THE LANDMARK HOTEL
CHARLOTTESVILLE, VIRGINIA

MINOR FAMILY HOTELS
THE LANDMARK HOTEL
OCTOBER 2008

MAIN STREET ELEVATION COMPARISON

THE LANDMARK HOTEL
CHARLOTTESVILLE, VA

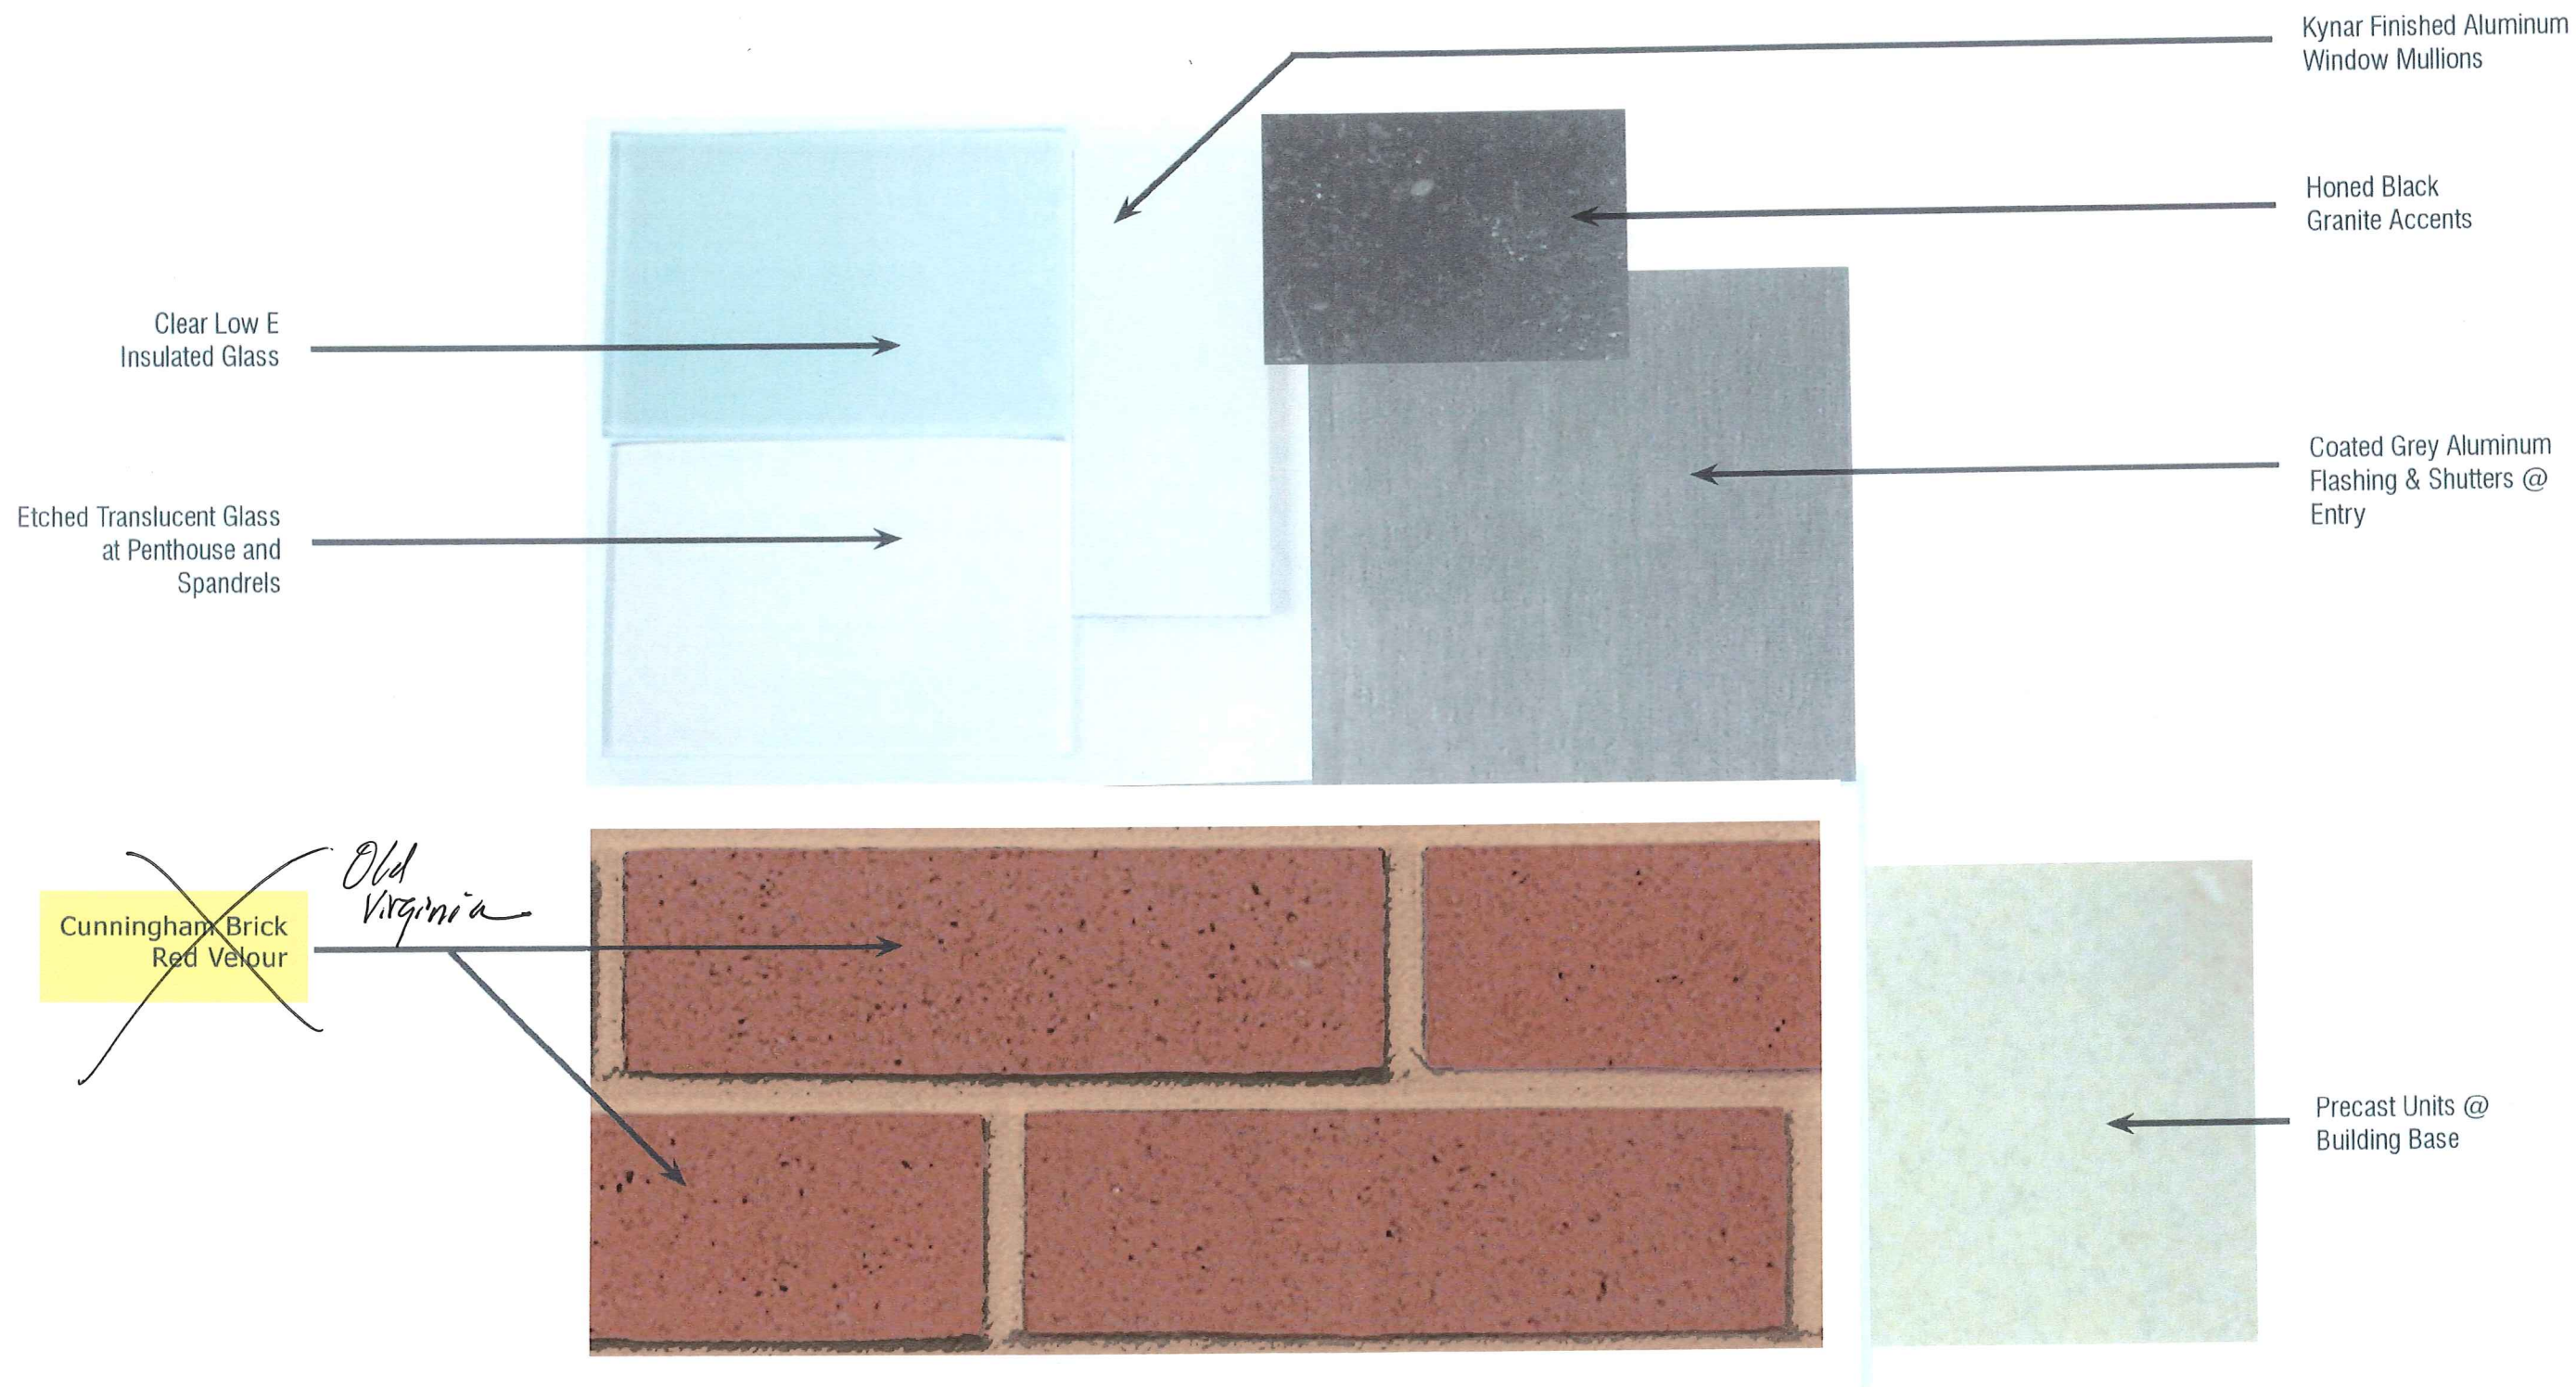
1/2" reveals

1. Canopy redesigned-
The canopy was changed and lowered through BAR approval.
2. Reduction of metal louvers- The louvers now show as glazing. *OK*
The louvers did not serve a function and it was replaced with glazing.

3. CVS party wall change-
The re-evaluation of the existing CVS party wall has been revised to show actual conditions. Since it was inaccurate in the original submission, the correct slope now shown will have modified some of the materials inaccurately shown near the Water street portion of this elevation. *OK*

4. Window/Butt glazed joint modification- *OK*
The guestroom windows previously had butt glazed joints shown. The joints were removed to avoid unsightly silicone sealant joints with clear glass. The windows were previously shown as metal panel and now are shown as glazing

5. Brick Insert banding- Row directly above canopy raised to accommodate the relationship between the canopy and the façade. Bands changed from red brick to precast inserts to match adjacent precast. *adjust height*
Differences in materials working against each other in expansion/contraction will ultimately cause problems with cracking.

6. Addition of parapet- *condition to make it open - glass or metal rail*
Original design did not take into consideration that people would be walking on the terrace and would need a barrier for safety.

7. Screen Wall- A mechanical screen wall was added through BAR approval to mask the mechanical units that service this building. *OK*
The screen wall height is adjusted to accommodate the actual mechanical units to be used.

8. Addition of pantry room bump out- *OK*
A bump out was added to accommodate the necessity for a pantry and storage for servicing the terrace.

9. Brick detail addition- The brick "columns" from the light box were adjusted to stretch further down this elevation.
The unadorned blank brick wall needed detail to break of the monotony of the blank wall.
10. Brick Recess to Small Windows- The brick recesses adjacent to guestroom windows are now replaced by windows.
The small windows now serve the guestrooms to allow natural light in as well as match the Second Street elevation in look and function.
